ADDENDUM NO. 2

**PORTER TOWNSHIP ADMINISTRATION BUILDING
Valparaiso, IN 46341**

This Addendum forms a part of and modifies the Bidding Requirements, Contract Forms, Contract Conditions, the Specifications, and the Drawings dated August 25, 2026 by Gibraltar Design, Inc. Acknowledge receipt of the Addendum in the space provided on the Bid Form. Failure to do so may subject the Bidder to disqualification.

This Addendum consists of Pages ADD 2-1 through 2-2 and attached Addendum No. 2 from Gibraltar Design, Inc. dated September 18, 2026 and consisting of 5 pages, Specification Section 08 14 32 - Stile and Rail Wood Doors, Specification Section 33 46 16 - Outlet Structures for Stormwater Ponds, and 15 drawings.

1 MECHANICAL HVAC FIRST FLOOR PLAN - SCOPE B
M-101 1/8" = 1'-0"

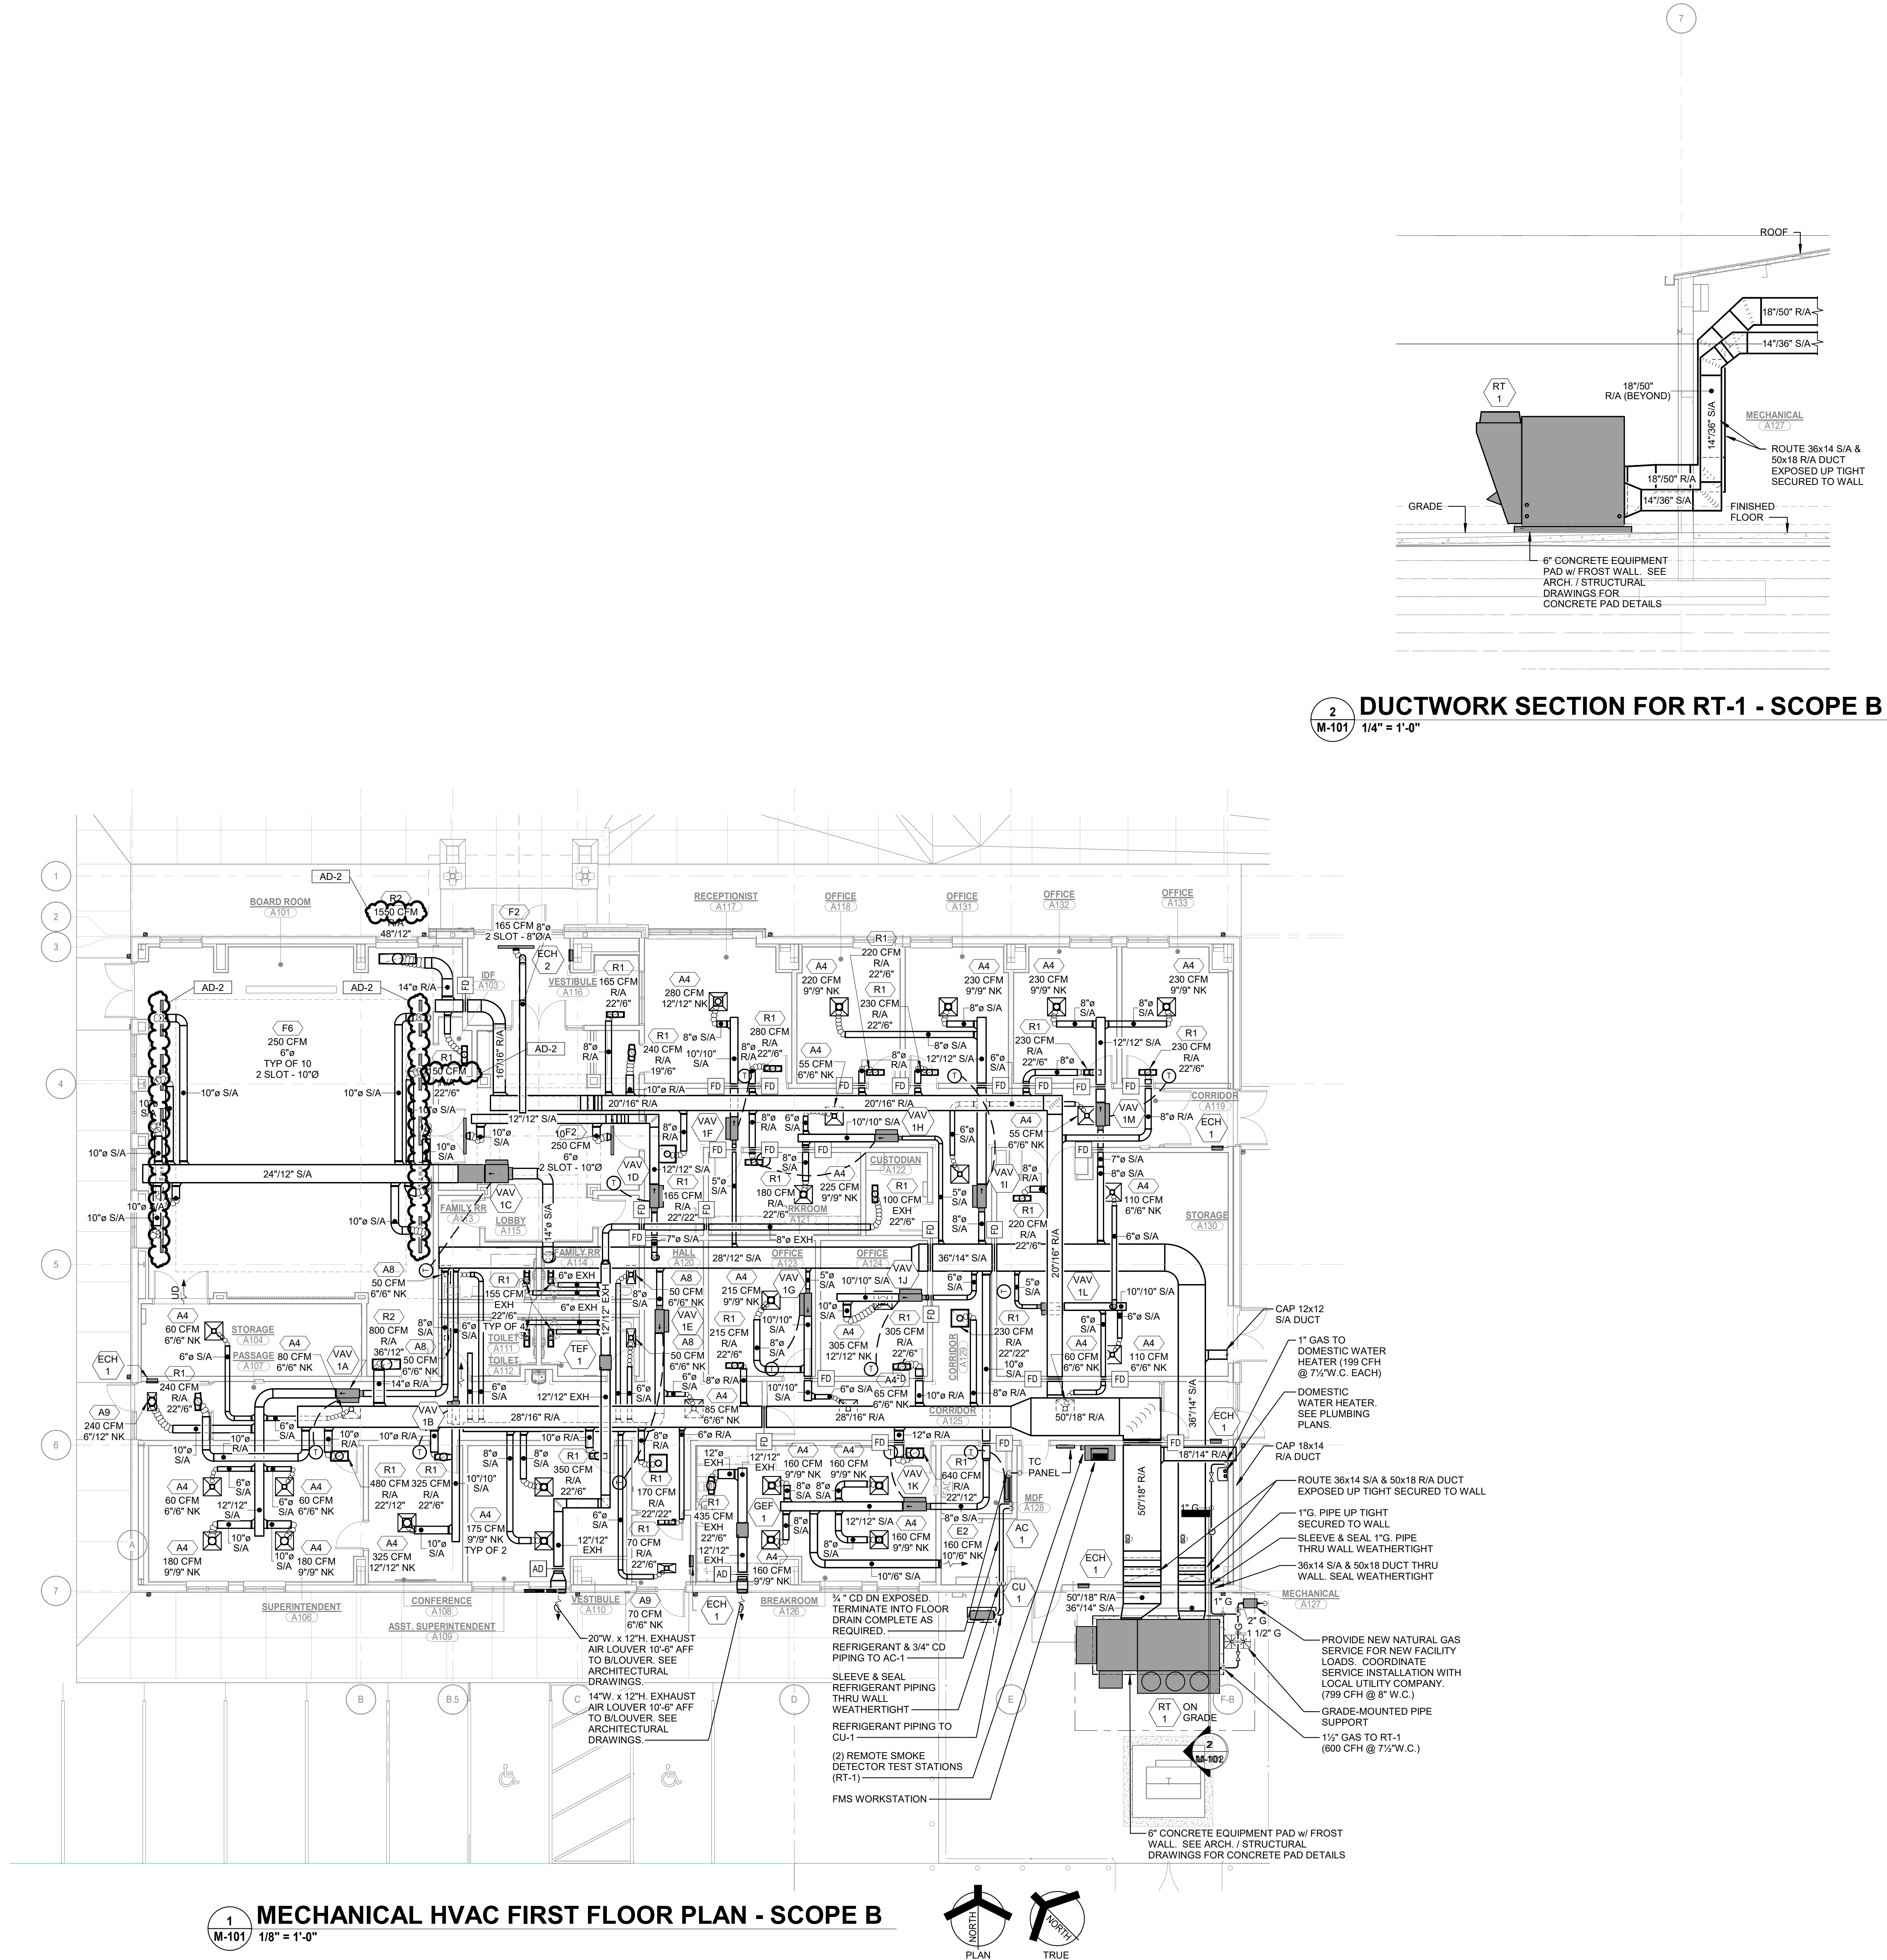
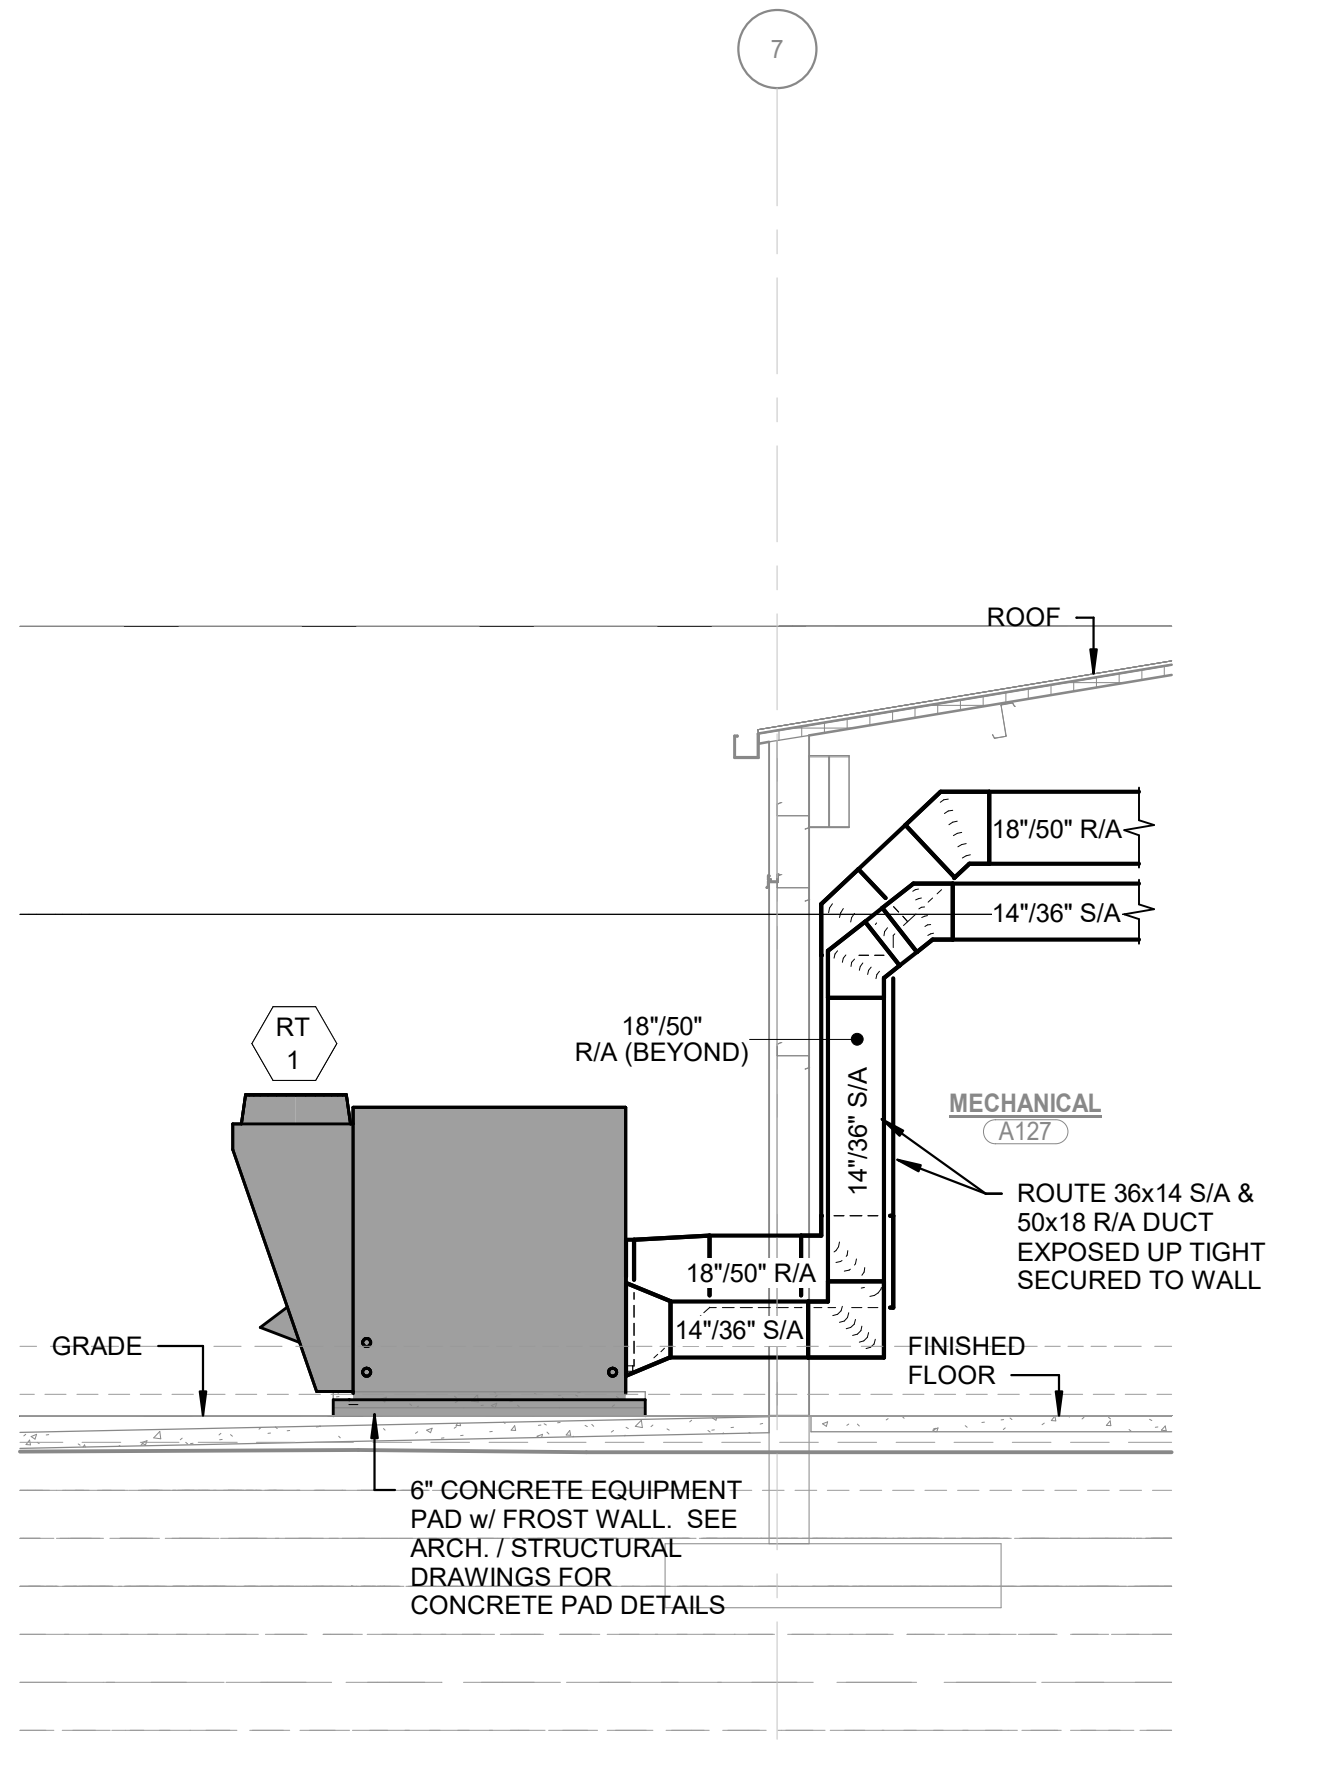
- A. Refer to revised, full-size drawings, included in this Addendum, for revisions.
 - 1. Modified the locations of the supply air diffusers in Board Room A101 to be centered and evenly spaced with the adjust ceiling bulkhead.
 - 2. Modified the return airflow quantity on the return air grille on the north side of Board Room A101.
 - 3. Modified the return airflow quantity on the return air grille in IDF A103.

1 ELECTRICAL LIGHTING FIRST FLOOR CEILING PLAN - SCOPE B
EL101 1/8" = 1'-0"

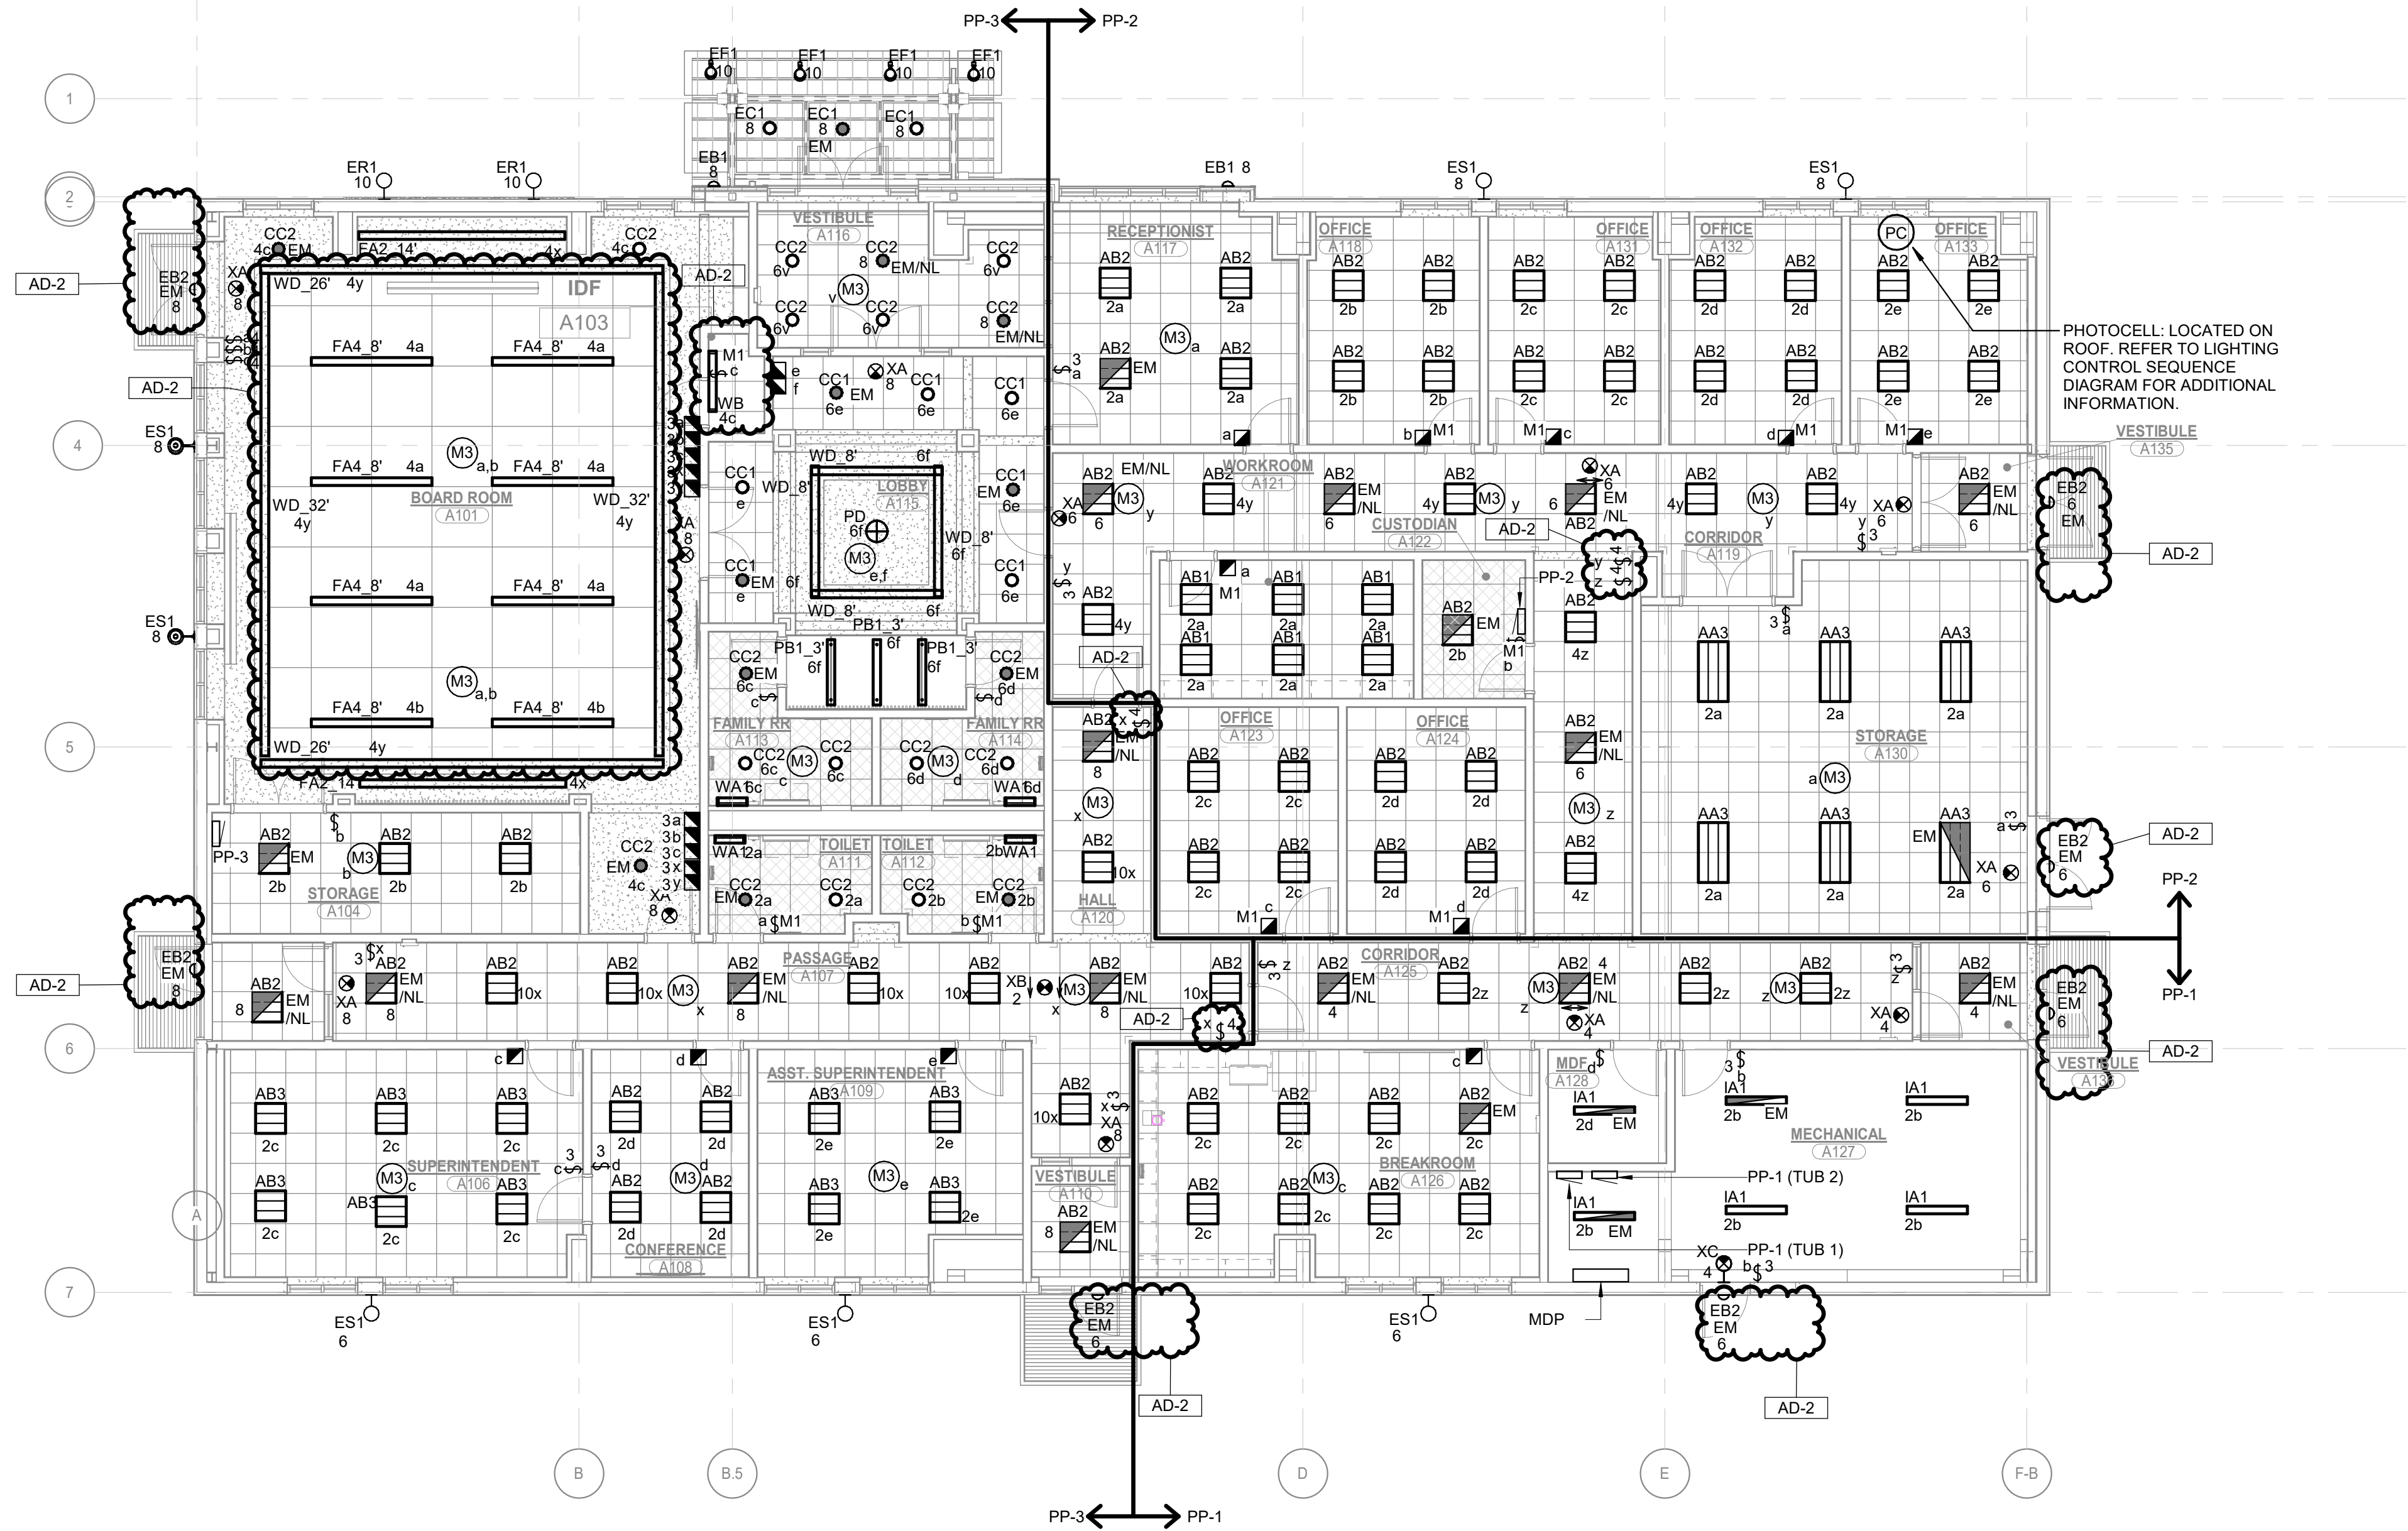
- A. Refer to revised, full-size drawings, included in this Addendum, for revisions.
 - 1. Revised exterior fixture types.
 - 2. Added switches in corridors.
 - 3. Added WB fixture to closet.
 - 4. Revised cove fixture lengths and locations.
